ADDENDUM NO. 2

Item No. 15A – Extend Taxiway Y, Construct ARFF Response Road, Realign Perimeter Road & Associated Improvements

Abraham Lincoln Capital Airport

REASON FOR ADDENDUM:

SUMMARY OF QUANTITIES

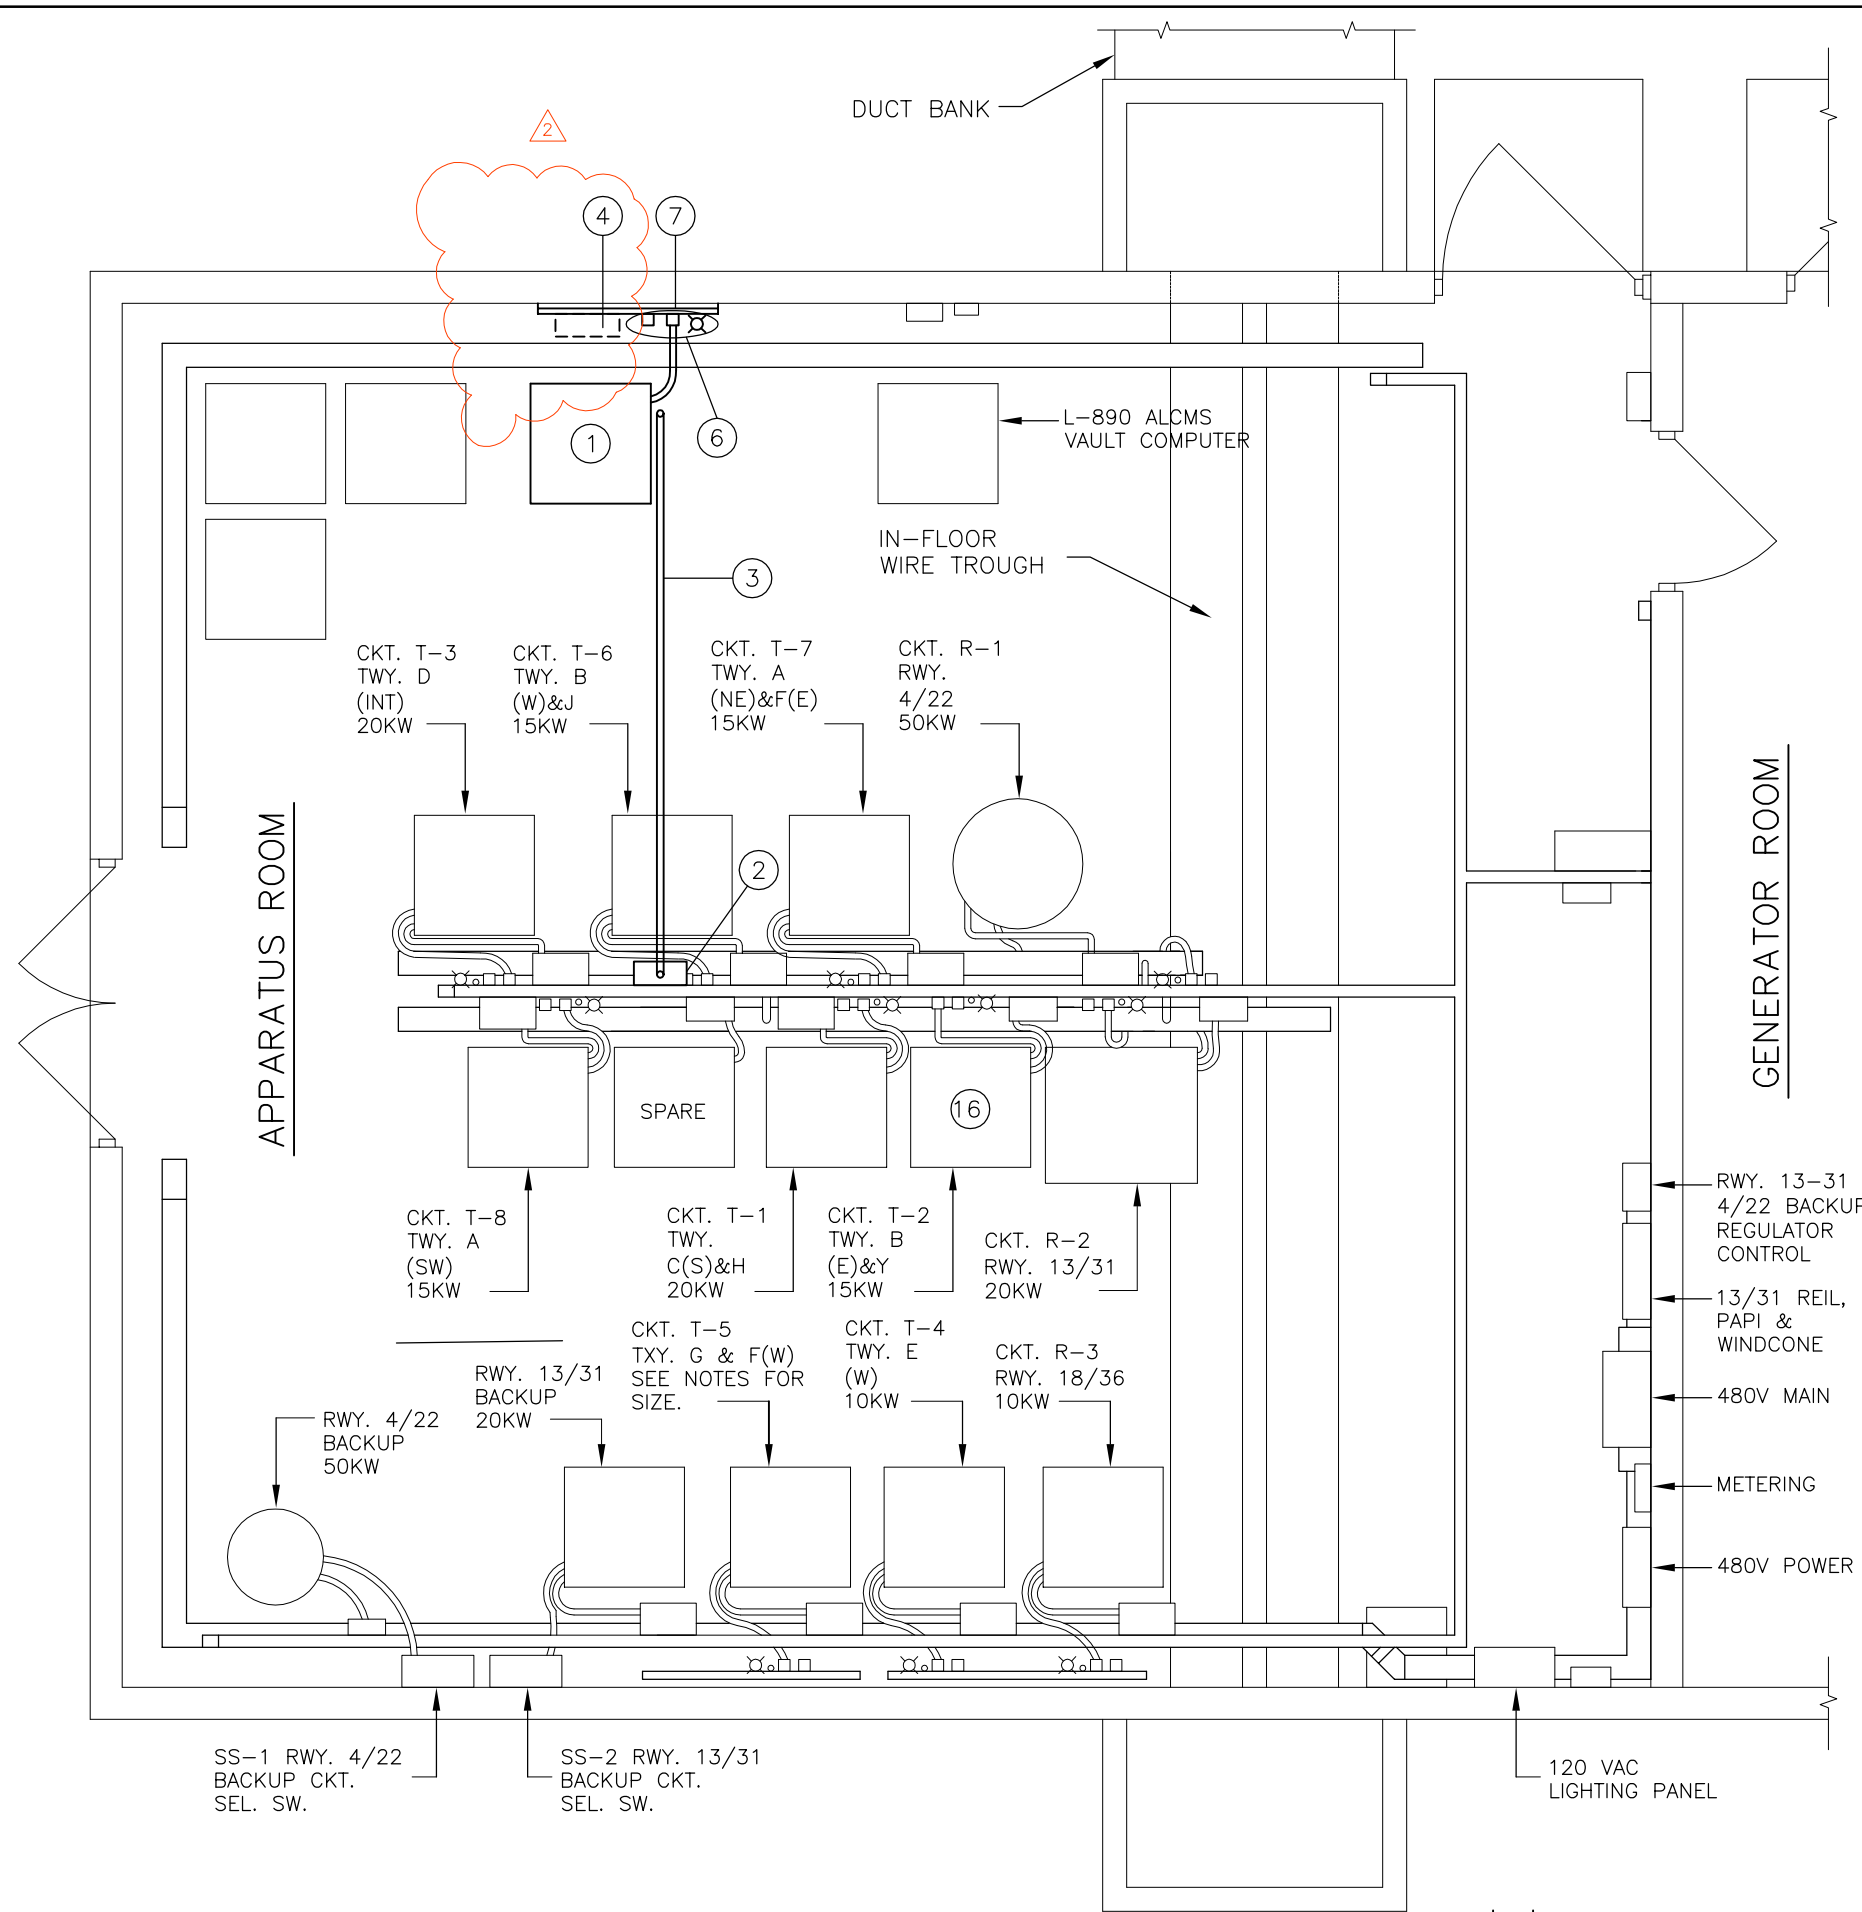
Delete work for pay item **AR801236** – Lighting Control Modifications from the Construction Plans, Special Provisions, & Schedule of Prices.

Sheet 03 **REPLACE:** Plan Sheet 03 of 106 with the attached *Revised* Addendum # 2 Sheet 03.

VAULT PLAN
 1/4" = 1'-0"

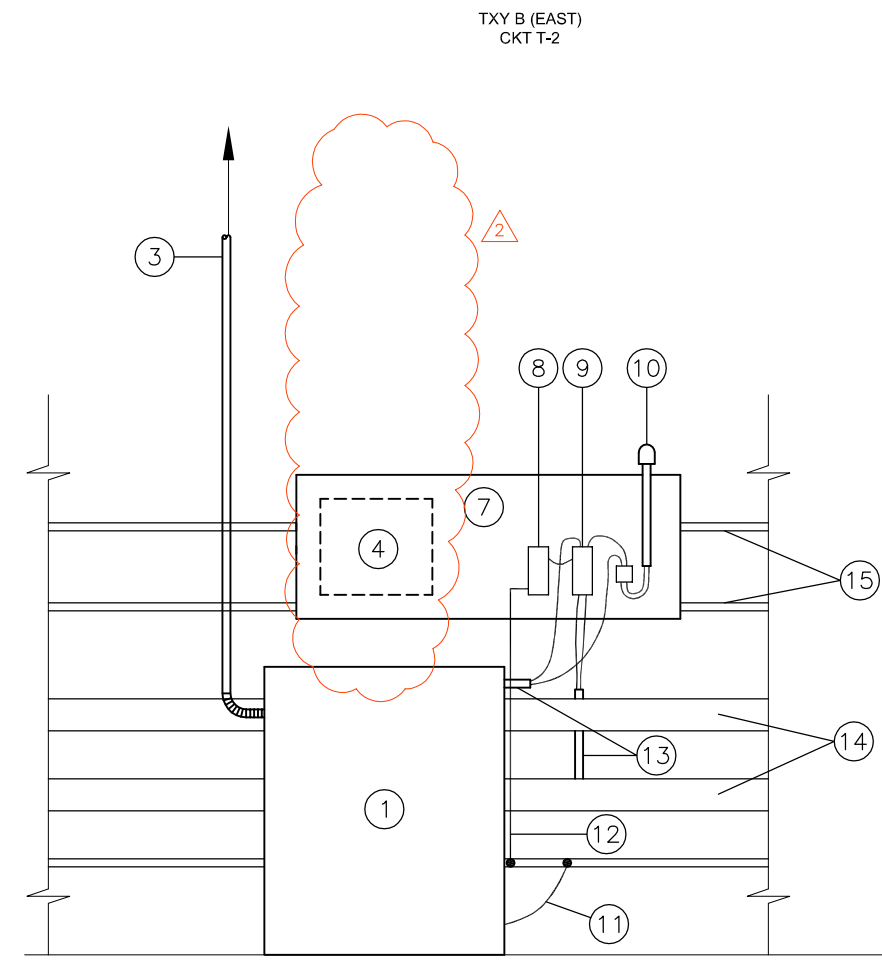
Sheet 74 **REPLACE:** Sheet 74 of 106 with the attached *Revised* Addendum #2 Sheet 74.

- 5 (DELETED)
- 6 NEW TAXIWAY EDGE LIGHT, PLUG CUTOUT AND GROUNDING DISCONNECT.
- 7 NEW MOUNTING PANEL, SIZED AS REQUIRED, PAINTED WHITE. ATTACH TO EXISTING STRUT-TYPE FRAMING.

- 1 NEW TAXIWAY Y, Y1, Y2 REGULATOR (CKT. T-9), L-828, 10 KW, 480V INPUT, 3-STEP 6.6A OUTPUT. PROVIDE ENGRAVED NAMEPLATE READING:
 TXY Y
 CKT T-9
- 2 NEW SQUARE D 480V, 30A, 3P PLUG-IN BUSWAY FEEDER CIRCUIT BREAKER. INSTALL IN EXISTING OVERHEAD SQUARE D BUSWAY. (NOTE: ONLY TWO POLES SHALL BE USED.) PROVIDE ENGRAVED NAMEPLATE READING "TXY Y".

- 3 NEW TWO #10 THWN, ONE #10 GROUND IN 3/4" GRS CONDUIT TO NEW REGULATOR. CONNECTION TO REGULATOR SHALL BE VIA LIQUIDTIGHT FLEXIBLE METAL CONDUIT.
- 4 PROVIDE SPACE FOR FUTURE ACE® UNIT.
